Appl. No. 10/616,943
Amdt. dated November 4, 2004
Reply to Office action of August 4, 2004
Page 8

Docket No. 2957-136
Superconducting rotor with cooling
system
REPLACEMENT SHEET

Fig. 1

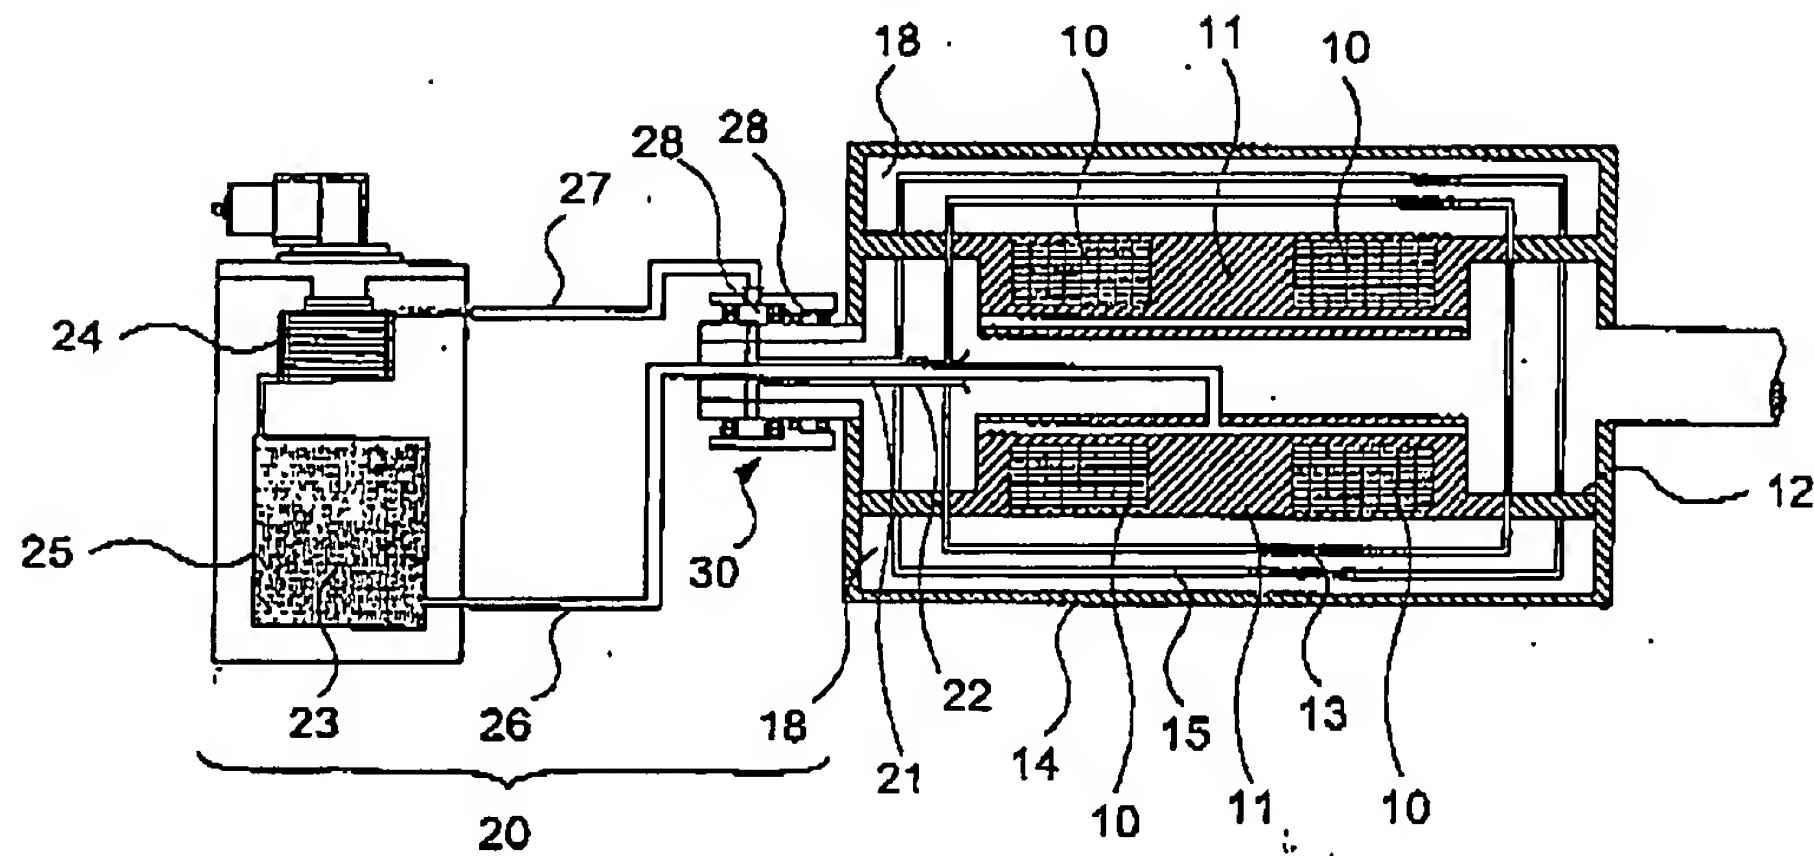
Attached is a correct Fig. 1 adding the label "PRIOR ART" thereto.

PRIOR ART
